Our Reference: 2019/3669-L01-PS-Transport Response

The Water House, Millfield Lane - 2019/5226/P

TTP Consulting has been instructed by Orcadian Planning to provide a response to comments submitted on behalf of Kenwood Ladies Pond Association by WSP in a letter dated 27th November 2019.

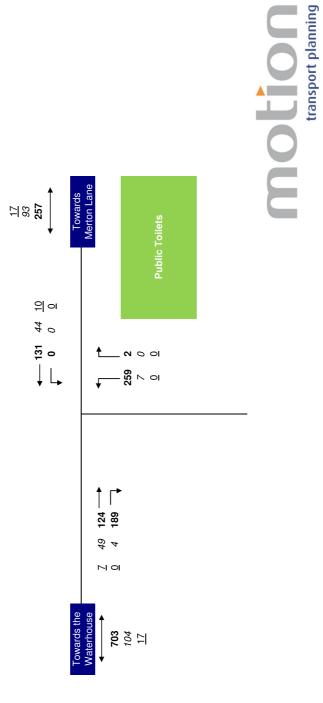
WSP has noted that is it understood that pedestrians predominately walk along the northern side of the road to allow vehicles to pass when encountered, but has provided no evidence to support this assertion. I have no data to dispute this but I note that in the vicinity of the site, many pedestrians will be travelling to and from the Ladies Pond, which is on the southern side of Millfield Lane and that if approaching from the west, vegetation on the northern side of the road (which can be seen on the following image taken today) could discourage pedestrians from using this side of the road when a vehicle passes.
